AMENDMENT

IN THE DRAWINGS:

FIG. 2

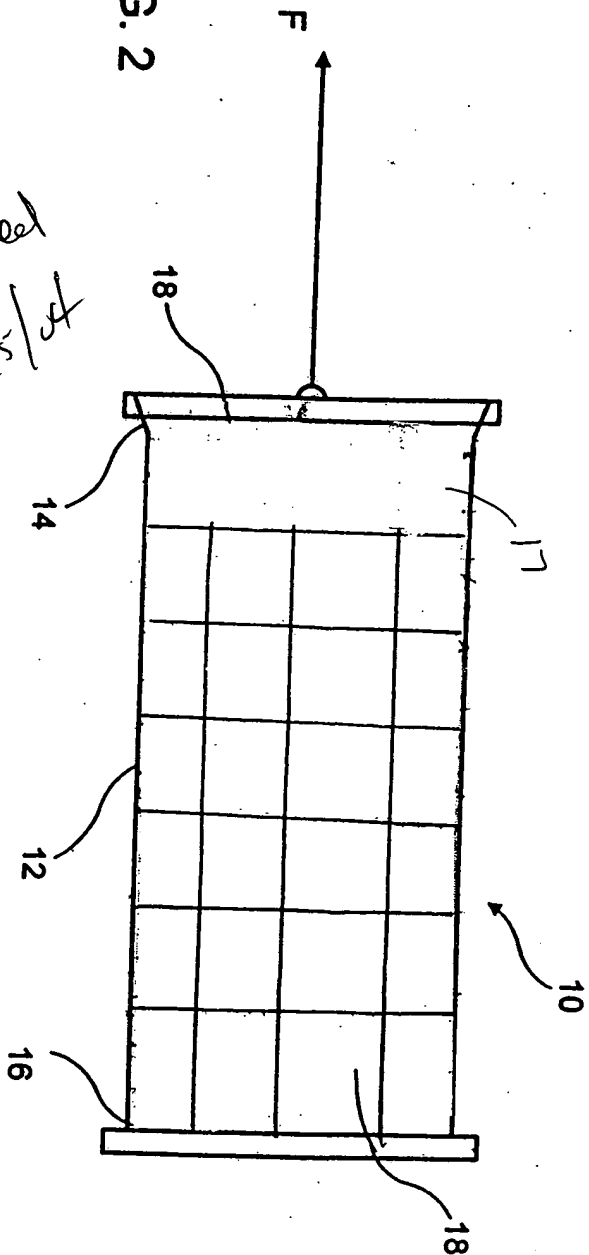
New figure 2A provides end caps 19 for filling and emptying the vessel via ports 21. In addition, figure 2 is amended to provide a length of a segment 17 being equal to the circumference of the vessel.
